Safety Evaluation Report

Renewal of the Facility Operating
License for the Dow Chemical
Company Dow TRIGA Research
Reactor

Docket No. 50-264

U.S. Nuclear Regulatory Commission

Figure 2-2 The DTRR LCC

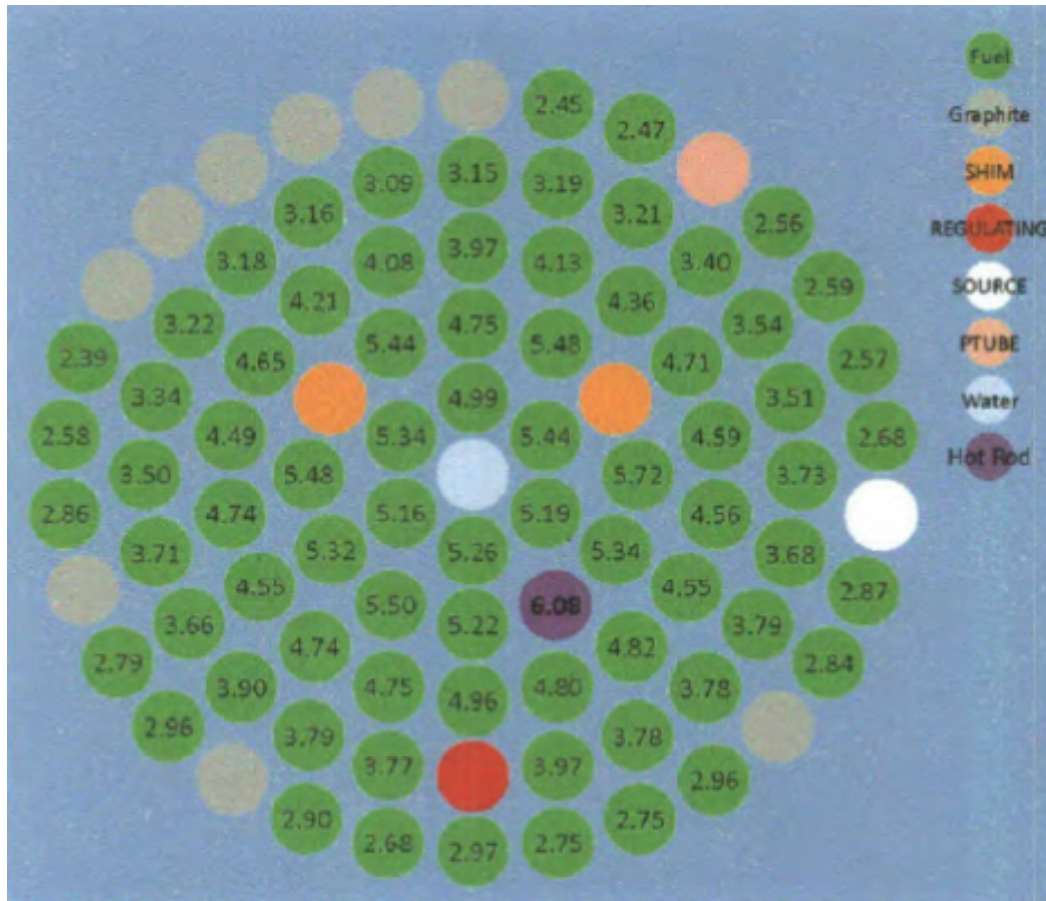
The NRC staff reviewed the DTRR LCC, as shown in Figure 2-2 of this SER, and based on the DTRR neutronics report, Figure 15 was used to determine the results of the DTRR accident analyses. The DTRR LCC used 75 fuel elements in the 300 kWt core. Since four fewer fuel elements were used in the analysis, the average power in each fuel element increased from 3.75 kWt (300 kWt/79 fuel elements) for the 2011 core configuration to 3.95 kWt for the LCC. The peak fuel element power was located in lattice position C6. The DTRR neutronics report, Section 3.6, established the maximum fuel element power that could be expected for the DTRR core. The result for the DTRR LCC was a limiting fuel element power in the lead fuel element of 6.08 kWt for DTRR under any steady-state circumstances. The NRC staff concludes that the DTRR LCC is consistent with the guidance in NUREG-1537, Section 4.5.1.

Figure 2-7 Fuel temperature coefficients

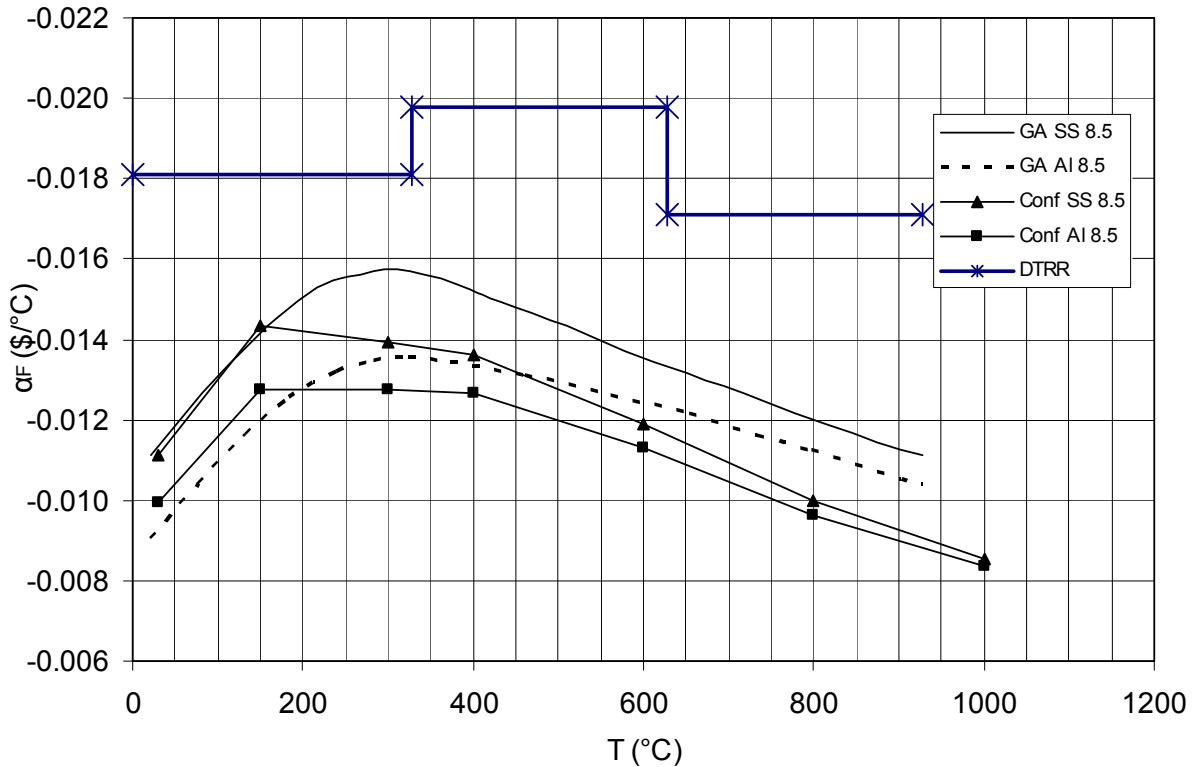
Figure 2-7 provides the referenced GA results, the DTRR results (Figure 2-5), and the NRC staff's confirmatory results. The NRC staff's confirmatory calculations validated the value and trend of the GA results. The values that the licensee demonstrated are consistent (same order and trend) with the referenced GA results. The NRC staff used the FTC values calculated by the NRC staff for the confirmatory calculations of the Reactivity Insertion Accident (see SER Section 4.1.2) and the Uncontrolled Rod Withdrawal Transient (see SER Section 2.5.4).

Figure 2-8 Uncontrolled rod withdrawal–total reactor power

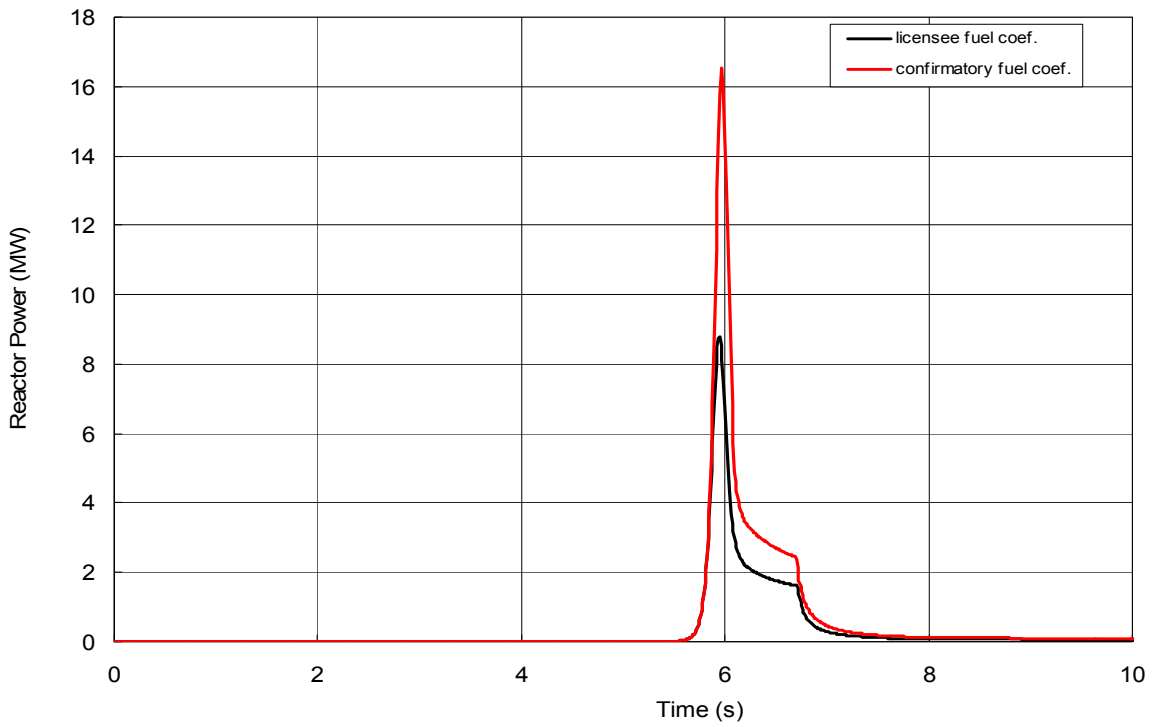
The NRC staff's analysis used the confirmatory value of the FTC, which provides conservative results (by a factor of 2 greater than the licensee's results as shown in Figures 2-8 and 2-9), and determined that the scram signal occurs at 5.71 seconds at a power of 300 kWt. The power level continues to rise until the FTC overcomes the transient at 16.55 MWt occurring at 5.97 seconds. The control rods begin inserting at 6.71 seconds and finish inserting 1 second later. Since nuclear processes terminate much more rapidly than T-H processes, the peak fuel temperature, which begins the transient at ambient temperature of 25 degrees C, peaks at 268 degrees C.

The NRC staff finds that the peak power reached, for a very short time, does not pose a challenge to the fuel element safety limit of 500 degrees C. Consequently, the confirmatory calculation established the acceptability of the FTC, TS scram time value of 1 second, and the rod withdrawal rate of \$0.20 per second. The NRC staff finds that the reactivity insertion rate (\$0.14 per second) is below the TS maximum reactivity insertion rate of \$0.20 per second used in the present analysis, and therefore, acceptable.

Figure 2-14 Comparison of confirmatory and DTRR DNBR results

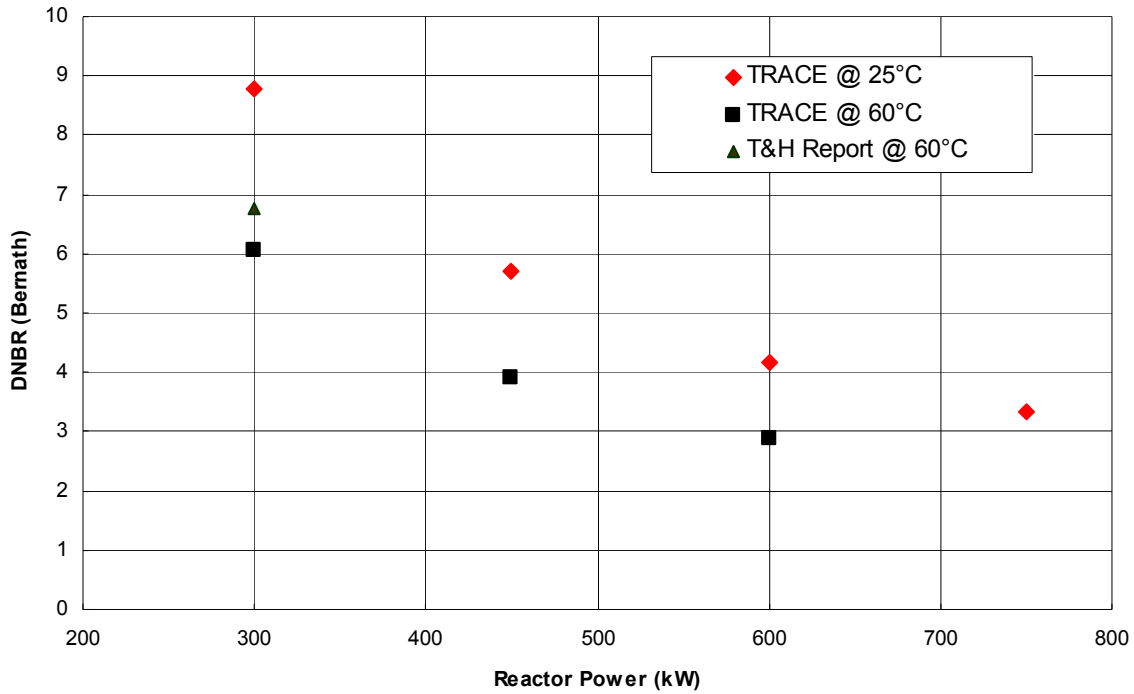
Figure 2-14 displays the results of the NRC staff's TRACE calculated DNBR values as a function of reactor power at the various power levels described in Figure 2-13. The calculations

were performed using a nominal reactor pool water inlet temperature of 25 degrees C and the TS limit on bulk pool temperature of 60 degrees C from TS 3.4, Specification 5. Figure 2-14 provides an illustration of the DTRR and NRC staff DNBR calculations. The NRC staff's methods used for the TRACE confirmatory analysis were equivalent to those used in the DTRR T-H report (Ref. 12). The NRC staff finds that the DTRR DNBR value is consistent with the NRC staff's confirmatory calculation.
